## **DEVELOPMENT APPLICATION**

### **PDPLANPMTD-2025/058097**

**PROPOSAL:** Additions & Alterations (Single Dwelling)

### **Response to Request for Information: Stormwater Discharge Option**

PROPOSED DRAINAGE PL

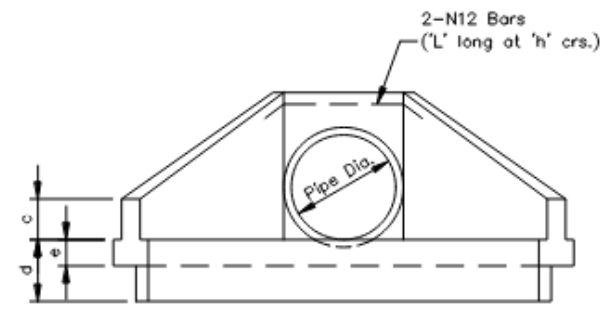
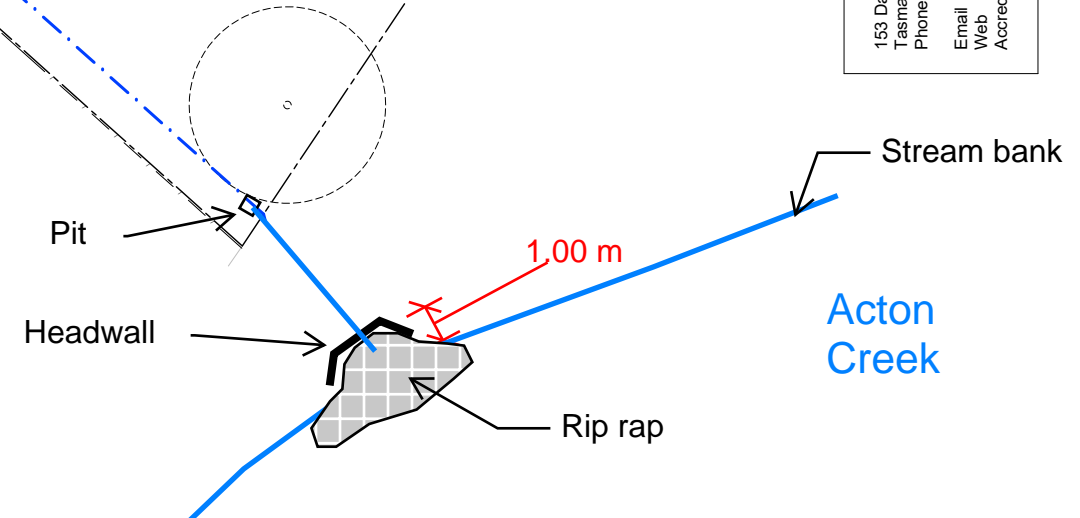
Following the Council's RFI dated 20 April 2026, we confirm **off-site discharge to Acton Creek** as the primary stormwater management strategy for the proposed extension at 24 Esplanade. This option is preferred to on-site absorption due to the high-water table (~1.3–1.4 m) and the limited area available for dispersal, which is also needed for parking. The site is also affected by significant inundation from Council's stormwater system, so on-site detention may be ineffective because the property already experiences surface water flows from an external source.

Stormwater from the roof is to be diverted via a DN 150 pipe into a pit -sized for depth of pipe at the boundary.  
Stormwater is to be directed to a concrete headwall as per TSD-SW17-v3 and TSD-SW19-v3

Lomandra or other water-loving grass species to be planted on the bank

The design will consolidate proposed roof runoff (catchment area of 320 m<sup>2</sup> into a single DN 150 drainage line (refer to site plan). This line will bypass the alternative proposed onsite absorption bed and discharge from a 400 mm pit located inside the property boundary to a headwall and out into Acton Creek, located to the east, west, and south of the property.

The DN150 (150 mm diameter) PVC pipe runs underground from the roof gutter areas to a 400 mm pit inside the site boundary. From there it flows to a headwall.

Position the headwall approximately 1 m back from the creek bank, dig no more than 200 mm below the pipe to install a precast concrete headwall structure embedded securely into the bank. Place geofabric around the base of the excavation.

The headwall will be approximately 800-900 mm wide and 500-700 mm tall, flush with the bank's slope. Refer to Tasmanian Municipal Standard Drawings (v3, Dec 2020) specifically TSD-SW17.

The pipe protrudes slightly (about 10–20 cm) beyond the headwall to direct flow away from the bank.
